From: Jamie Donaldson
Sent: Tuesday, December 13, 2022 5:00 PM
To: 'Mark Lowen'
Cc: John Eld
Subject: RE: Tian Hill apartments 22 119071 00
Attachments: Incomplete Letter-markup.pdf; Tree Assessment-Ron Rhodehamel.pdf

PLANNING REVIEW CHECKLIST

Subject Property: 2100 Block of Doaks Ferry Road NW
(Marion County Assessor's Map and Tax Lot No: 082W07C000200)

Ref#: 22-119071-PLN (Type II Application)
Subdivision / Urban Grown Preliminary Declaration / Class 3 Site
Plan Review / Tree Variance / Class 1 Design Review

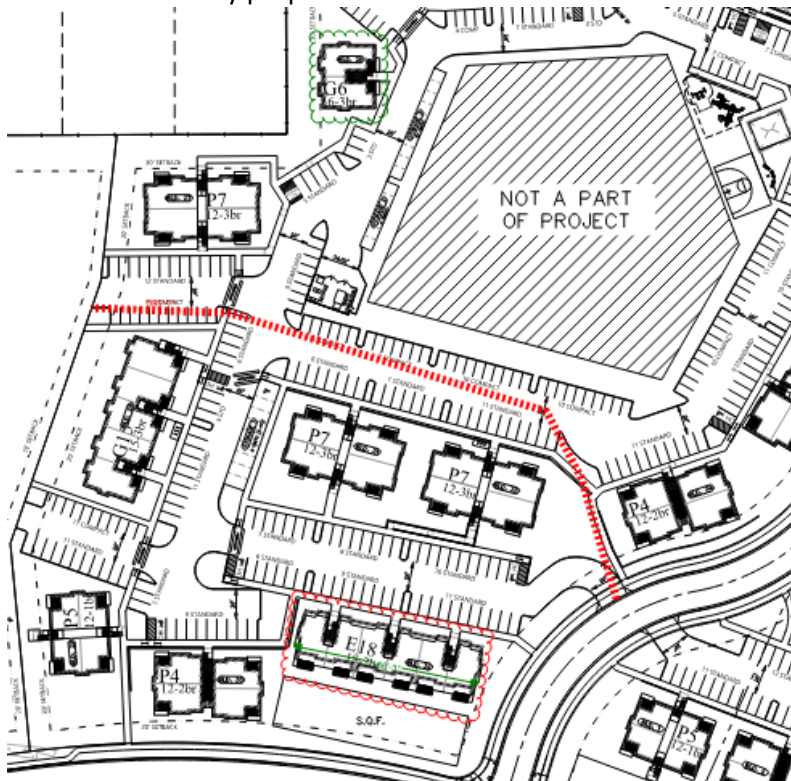
- There does not appear to be a new site layout uploaded for review of changes and conformance with the code, specifically for areas that were adjusted for trees, or parking areas where the minimum turnaround requirement was not being met. This may not hold up completeness, but an updated plan will be required for noticing and drafting of findings for the decision.
- There are still trees that appear to be designated for removal where parking is being provided. Because of your request for an increase to the maximum allowed parking, we cannot support the removal of these trees, or the adjustment, as both would essentially cancel out the approval criteria for the other.

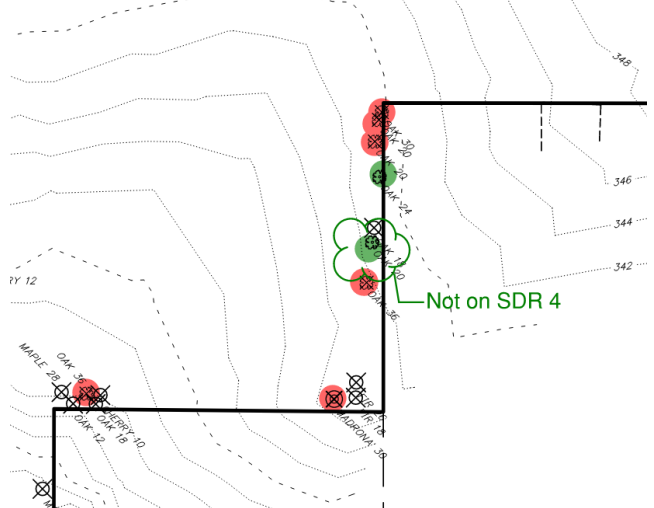
Item:	
<u>Submittal Requirements</u>	
TGE Form 	A Trip Generation Estimate (TGE) form must be completed by the applicant and submitted with the application. Please complete the required TGE form found here: https://www.cityofsalem.net/CityDocuments/trip-generation-estimate-form.pdf . Please also see completeness review comments from Public Works below.
Neighborhood Association Contact 	A copy of the required e-mail or letter to the neighborhood association, and a list of the e-mail or postal addresses to which the e-mail or letter was sent shall be submitted. Please upload the neighborhood association contact to the folder.
Written Statement(s) 	The written statement submitted for the UGA does not address the approval criteria under SRC 200.025 (d) & (e).

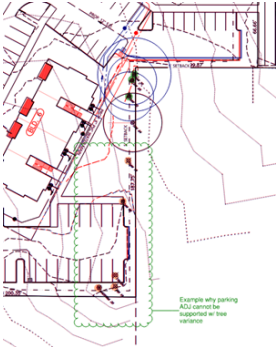
Class 2 Adjustment Application 3 ADJs? -Building length >150' ?-Street spacing >600' ?-Max parking	There are two separate documents that reference two adjustment requests. Both have similar cover sheets, but one references a request to the buildable width and the other is for an increase to the maximum allowed parking; however, no application was received for indicating the number of adjustments requested, and no fee has been paid. In addition, an adjustment to the building length of Building 11 is referenced in the Design Review written statement, with no supporting documentation. Please submit an application with the number of adjustments requested and please be aware that a written statement shall be provided how the proposal meets the criteria for each adjustment under SRC 250.005(d)(2) .
<u>Items of Concern</u>	Failure to address issues could result in denial of the application.
Title Report 	The title report lists several easements encumbering the subject property. These easements will need to be moved/removed if they conflict with the proposed plat. See also Public Works Comments below.
